<b>Delegated Report</b>	<b>Analysis sheet</b>		<b>Expiry Date:</b>		<b>13/09/2021</b>		
	N/A		<b>Consultation Expiry Date:</b>		<b>27/09/2021</b>		
<b>Officer</b>			<b>Application Number(s)</b>				
Obote Hope			2021/3484/P				
<b>Application Address</b>			<b>Drawing Numbers</b>				
4 Countess Road London NW5 2NT			Refer to decision notice				
<b>Proposal(s)</b>							
Erection of a rear dormer roof extension with roof lights to the front and rear elevations all associated with the use of the loft as habitable residential accommodation.							
<b>Recommendation(s):</b>		Refuse Planning Permission					
<b>Application Type:</b>		Full Planning Permission					
<b>Conditions or Reasons for Refusal:</b>		Refer to Draft Decision Notice					
<b>Informatives:</b>							
<b>Consultations</b>							
<b>Adjoining Occupiers:</b>		No. notified	<b>00</b>	No. of responses	<b>00</b>	No. of objections	<b>00</b>
				No. electronic	<b>00</b>

### 1.0 Proposal:

1.1 The development is for a rear dormer extension on the lower part of the roof slope measuring approximately 1.76m (W) x 1.68m (H) x 2.44m (D). Three conservation style rooflights are also proposed two to the front and one to the rear roof slo

Image 1, Shows the terrace which no. 5 is located consist of other rear dormer

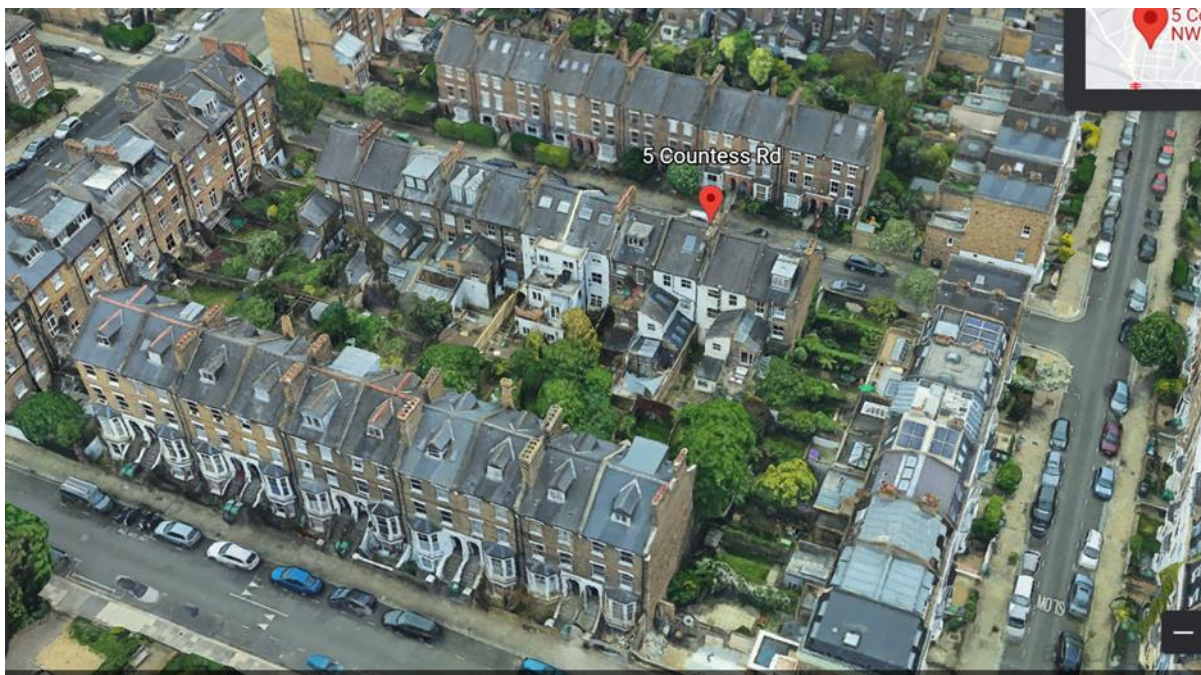
**2.7** The applicant has also drawn attention to fairly large rear roof extensions to the neighbouring dwellings and some others nearby. However, the context of which the rear dormer was granted permission is assessed below to understand the principle of the rear dormer extension. The example cited by the applicant is no. 5 Countess Road was granted planning permission in 2016 (2016/3480/P) and considered in context with the terrace of which the host building is located against the backdrop of the rear roof profile of Ospringe Road that benefits from rear dormer roof extension. Thus, the circumstances which led to them being appropriate in this location is accepted given the existing roof profiles which are altered with rear dormer addition which make the dormer extension part of the established character within this part of the conservation area. Moreover, the rear of no. 4 Countess Road is established by the lack of roof alterations, whilst the neighbouring property at no.2 has a roof addition which is also visible from Ascham Street this dormer roof extension was granted permission prior to the designation of the conservation area in 2011. Consequently, this permission does not act as a precedent in this case. As noted, the immediate context of this part of Countess Road remains largely unaltered and free of unsympathetic roof top additions and the presence of dormer windows elsewhere does not set a precedent for further harm in that context.

Image 2, Shows the terrace which no. 4 is located which is undeveloped with roof addition.

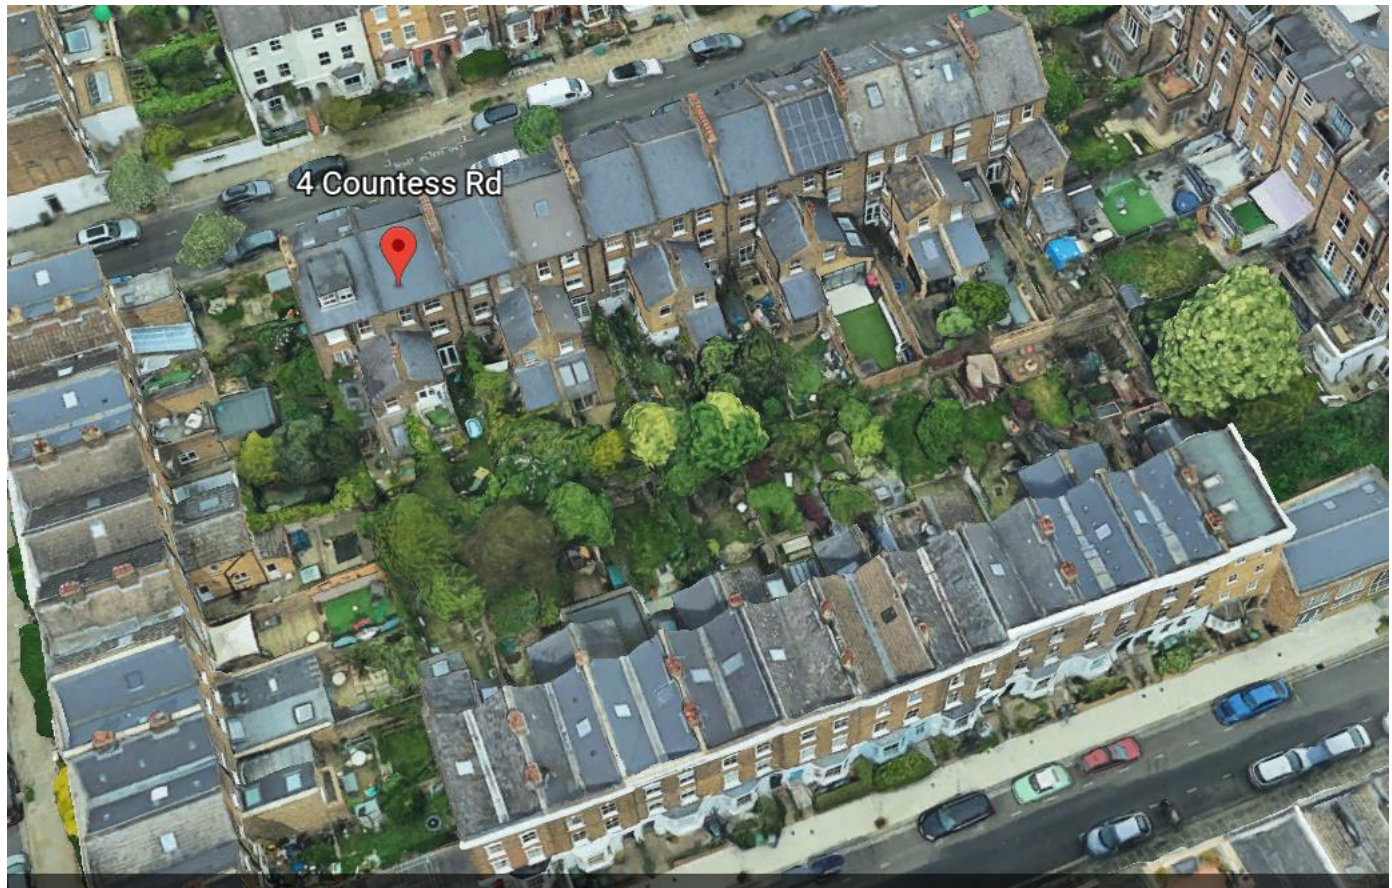
2.4 Within the terrace row that the application site is part of, there is a uniformed roof form. Only one of the eleven properties within the terrace row has a rear dormer (2005/1225/P) this is the neighbouring property at no 2 Countess Road. The Google aerial views shows that none of the other properties within the terrace row have been extended historically with rear dormers on rear roofslope. As such, dormer extensions are not part of the character of the terrace row and is unacceptable in principle.
